# Access Compliance Report

## Public Rights-of-Way

### (Curb Ramps)

Intersection ID: 50594	Main Street: BEAR_GRASS_LN	Cross Street: GRAY_WILLOW_RD	Location: E
ADA ID: 0D9B8E135957	Ramp Type: Perp	Initial Pass/Fail: Fail	Overall Compliance: No
Severity Score: 21.25			
Codes/Mitigation Info/Possible Solution		Field Measurements/Component Compliance

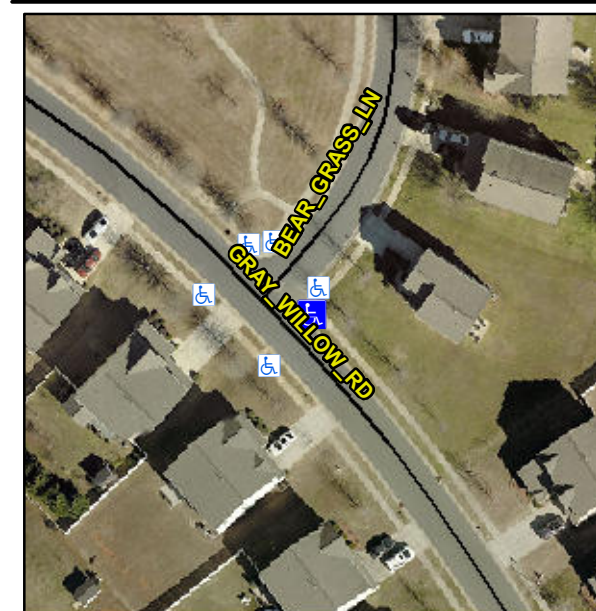
**Not Found, R304.5.1, R304.2.2**

Compliance	Description	Data	Compliance	Description	Data
N/A	Ramp Length (in)	47.0	No	Ramp Slope (%)	9.9
No	Ramp Width (in)	45.0	Yes	Ramp XSlope (%)	0.7
N/A	Flare Type LT	N/A	N/A	Flare Type RT	N/A
N/A	Flare Slope LT (%)	N/A	N/A	Flare Slope RT (%)	N/A
N/A	Flare Traversable LT?	N/A	N/A	Flare Traversable RT?	N/A
N/A	Landing Length (in)	N/A	N/A	DWS Provided?	N/A
N/A	Landing Width (in)	N/A	N/A	DWS Contrast?	N/A
N/A	Landing Slope (%)	N/A	N/A	DWS Length (in)	N/A
N/A	Landing X Slope (%)	N/A	N/A	DWS Full Width?	N/A
N/A	Landing Curb? (Y/N)	N/A	N/A	DWS Offset (in)	N/A
N/A	Shared Landing?	N/A			
N/A	Gutter Ponding?	N/A	N/A	Gutter Slope (%)	N/A
N/A	Gutter Lip Ht (in)	N/A	N/A	Gutter X Slope (%)	N/A
N/A	Painted X Walk1?	No	N/A	Painted X Walk2?	N/A
	X Walk 1 Direction	To SW		X Walk 2 Direction	N/A
N/A	X Walk 1 Width (in)	N/A	N/A	X Walk 2 Width (in)	N/A
	X Walk 1 Slope (%)	3.0		X Walk 2 Slope (%)	N/A
	X Walk 1 X Slope (%)	2.1		X Walk 2 X Slope (%)	N/A

**Remove & Replace Entire Ramp.**
